Before the  
FEDERAL COMMUNICATIONS COMMISSION  
Washington, D.C. 20554

File No. BPED-20070905ABF  
Facility ID No. 8197

**INFORMAL OBJECTION**

### **Engineering Statement**

# Overlap Area Calculation

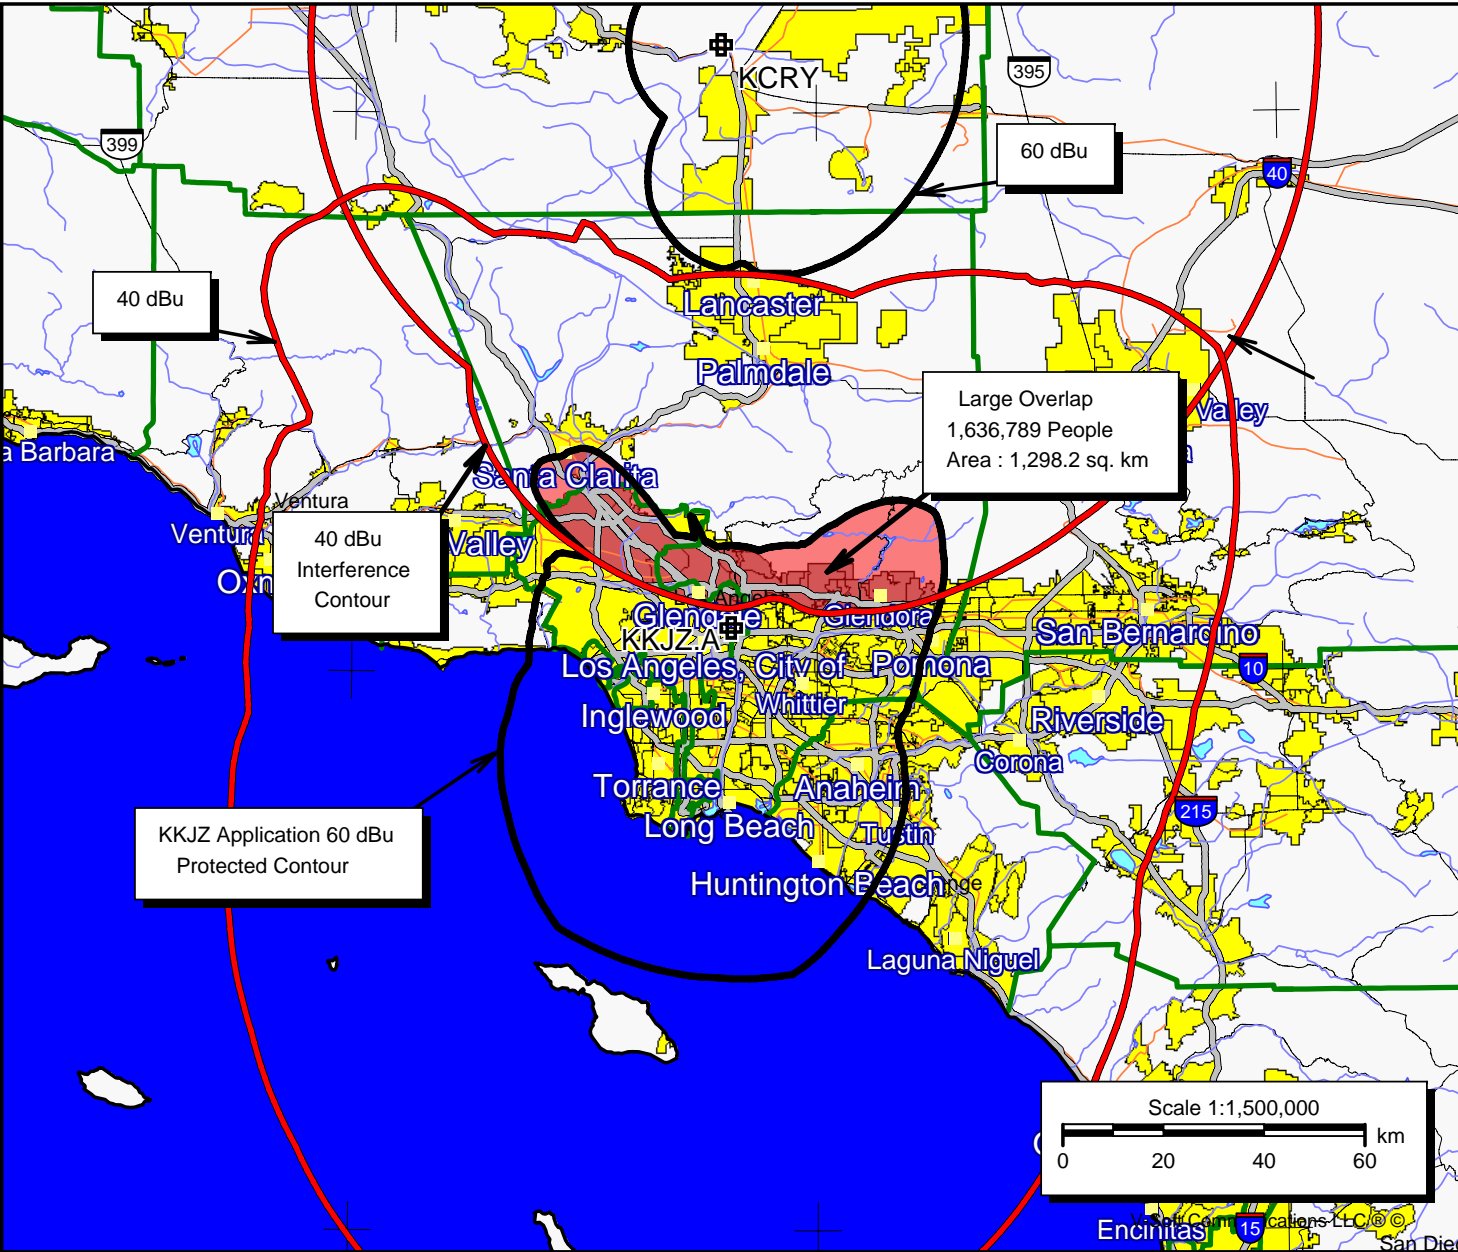
Moreover, the map exhibit annexed hereto shows that the extent of the proposed overlap between KCRY's 40 dBu interfering contour and KKJZ's 60 dBu protected service contour is significant, encompassing an area of 1,298.2 square kilometers with a population of 1,626,789. CSU argues that, due to intervening terrain, real interference will not exist. We note, however, that CSU's argument fails to define the extent of terrain roughness or delta h between KCRY's transmitter site and the area of prohibited contour overlap. That failure is significant and, without such a showing, CSU should not be permitted to rely upon the use of an alternative propagation method such as Longley-Rice. Further, the proposal fails to define the impact of resulting knife-edge refractions within KKJZ's protected signal area and within KCRY's protected contour. Consequently, the rationale for granting a waiver has not been presented in this case.
